R44

SERVICE BULLETIN SB-19

SUBJECT: Lateral Cyclic Trim Assembly Spring Shaft Wear

FIGURE 1

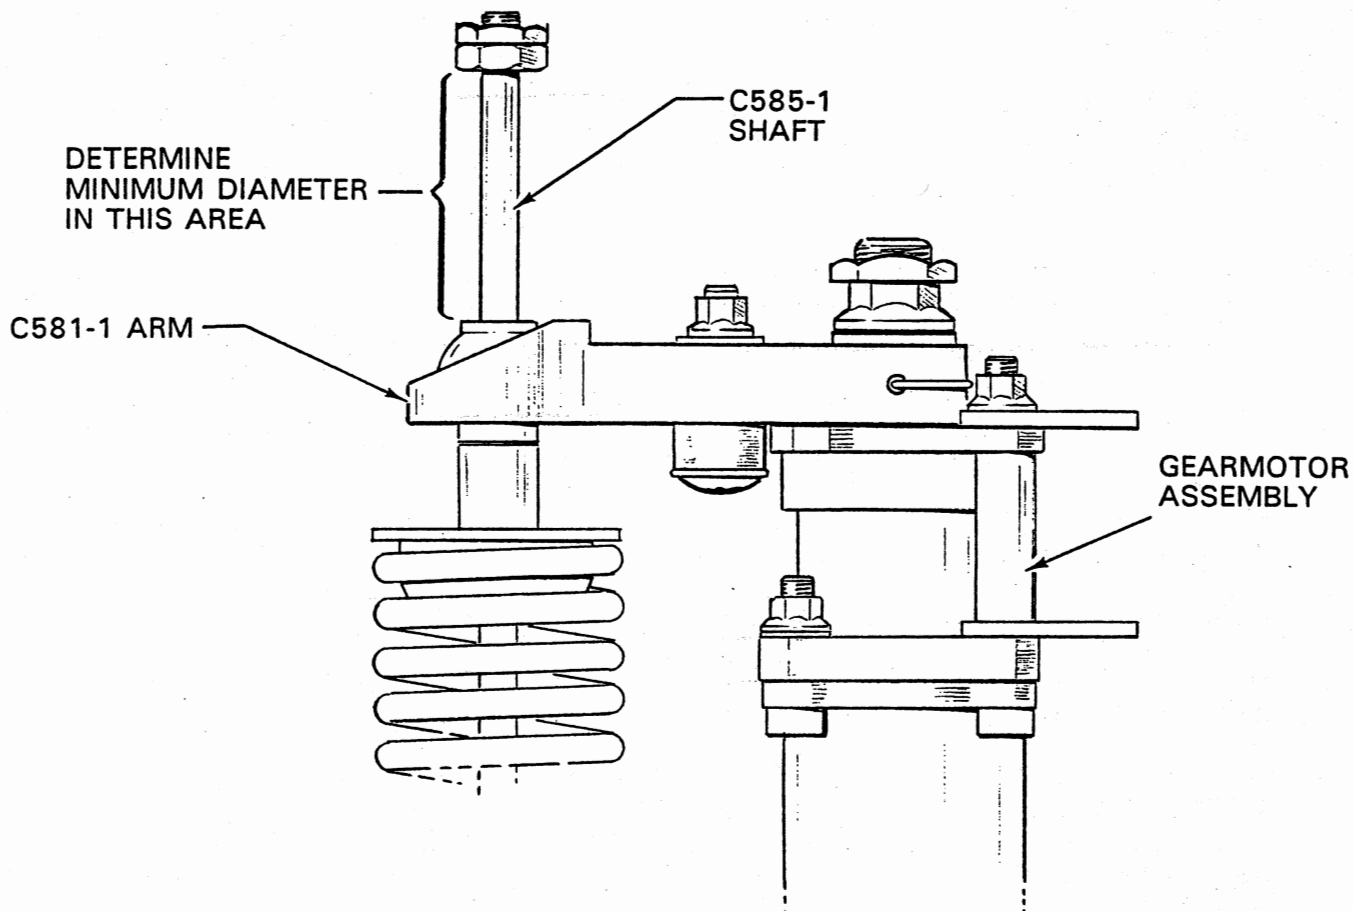
4. Move cyclic stick to left stop to compress trim spring.
5. Refer to figure 1. Determine minimum diameter of exposed portion of C585-1 shaft by measuring at several places.

6. Diameter of new shaft is 0.248 inch. If shaft diameter decreased more than 0.001 inch per 100 hours time-in-service OR if shaft diameter is less than 0.238 inch, order KI-109 kit and replace C585-1 shaft and C581-1 arm using instructions supplied with kit. Note: if minimum shaft diameter is less than 0.218 inches, shaft must be replaced prior to further flight.

7. If shaft minimum diameter is within allowable limits, clean and lubricate shaft with A257-1 grease (ref R44 Maintenance Manual Section 1.440) as required.
8. Install radio rack, avionics face, and avionics.
